Replacement of 8DB 355 024-681 by 8DB 355 013-681

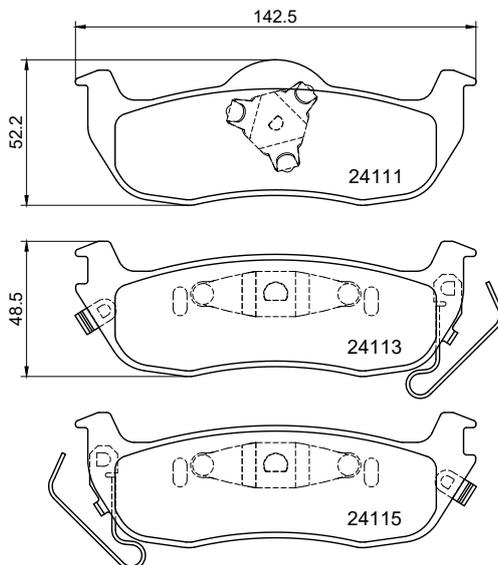
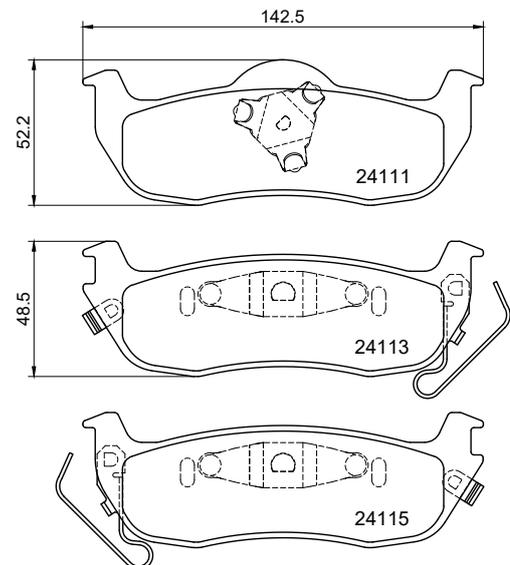
Hella Pagid is now able to harmonize the references 8DB 355 024-681 and 8DB 355 013-681. It was proven that 8DB 355 013-681 can also cover the applications of 8DB 355 024-681. Therefore Hella Pagid will replace 8DB 355 024-681 by 8DB 355 013-681.

The difference between them is the thickness and 8DB 355 024-681 contains also accessory (sliding rail). For the future, Hella Pagid will offer only the thinner version and without sliding rail, that is 8DB 355 013-681. There will be no difficulties during installation and operation.
